Tax ID # 04314476
ON-SITE SEWAGE DISPOSAL SYSTEM
HOWARD COUNTY HEALTH DEPARTMENT
BUREAU OF ENVIRONMENTAL HEALTH

WTC Contractors Inc. IS PERMITTED TO INSTALL ALTER

ADDRESS: 2728 Jennings Chapel Road PROPERTY OWNER: George Boyer

WALL CHECK DRAWING
 LANDS CONVEYED TO
 GEORGE M. BOYER
 LIBER 4764 AT FOLIO 314
 2728 JENNINGS CHAPEL ROAD
 FOURTH ELECTION DISTRICT
 HOWARD COUNTY, MARYLAND
 SCALE: 1" = 100' JULY, 2010

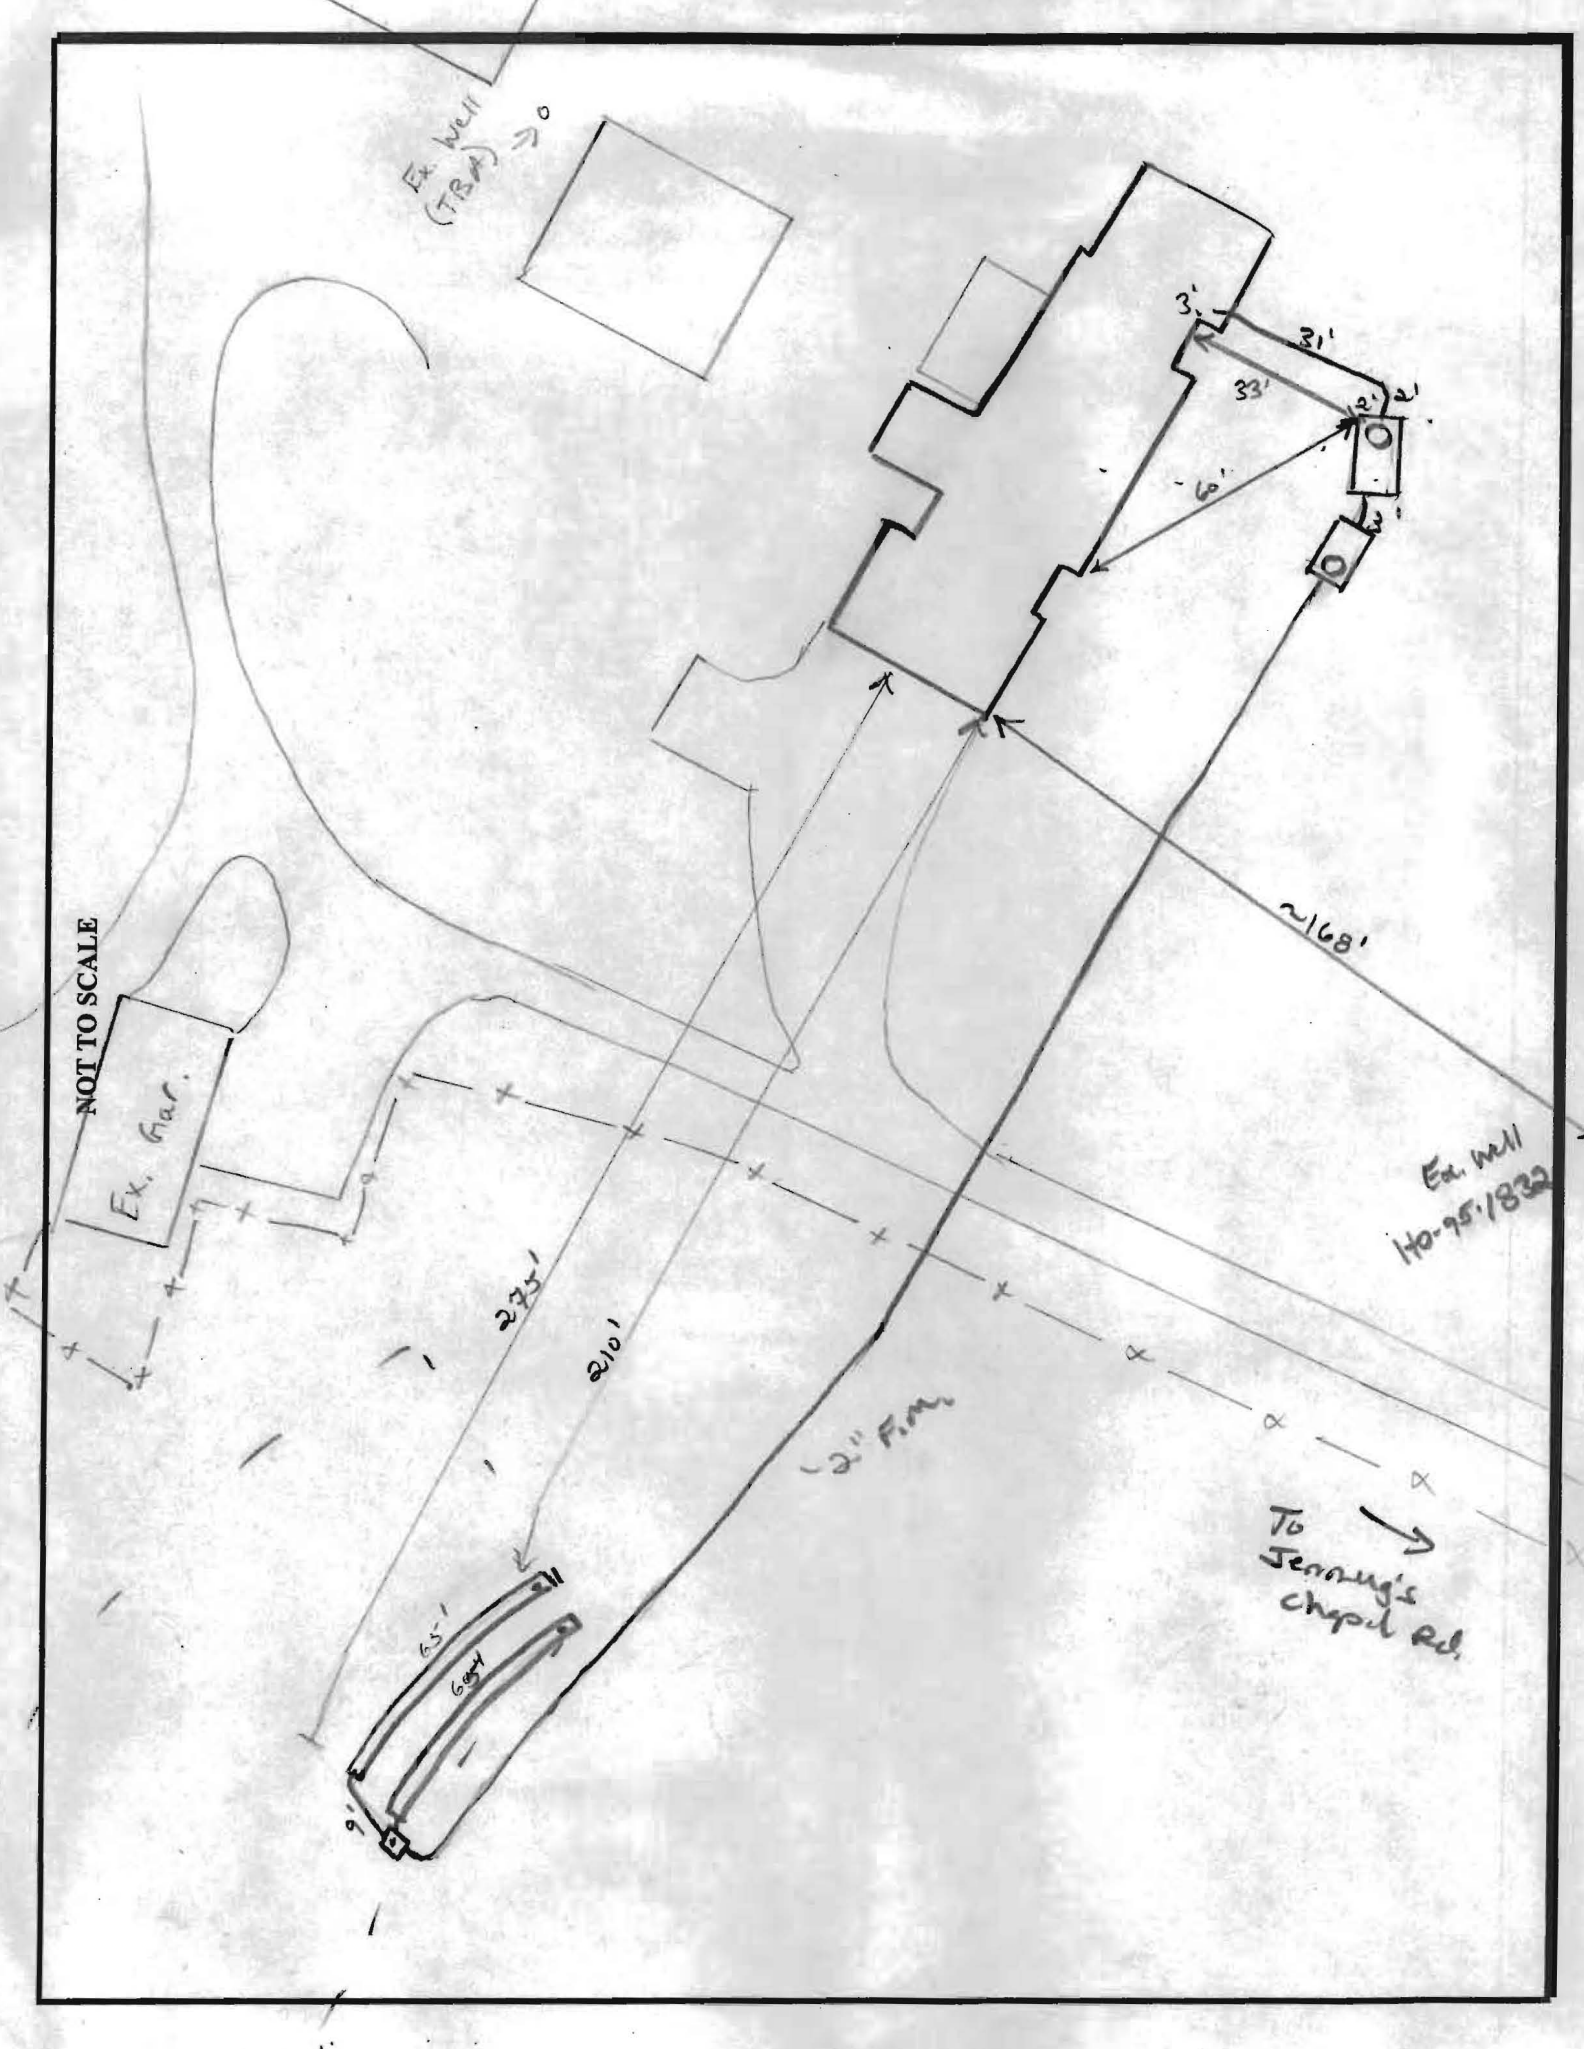
3/24/11 Contractor to keep tanks 20' from dwelling and out of swale area. F.M. to cross well line. Should go deep enough (2.4') to cover below to be installed well line. Set D box top middle of septic area install 2x6.5' timbers on contour. (KW)

3/28/11 Tanks set. F.M. started. Explained to contractor how to set pump. (B lock etc). No timbers started (KW)

3/29/11 Top trench completed. Machine broke down. Stayed on-site until they got second trench completed. OK to cover all work. Need P/A test for final approval (KW)

6/23/11 Arrived on-site for a P/A only to find electrician had no alarm float installed in the p.t. and all electrical components need to be installed outside tank. P/A test fails. Everything looks good inside the house (KW)

6/24/11 P/A is approved - All electrical components installed outside of tank and alarm float installed. (MS)
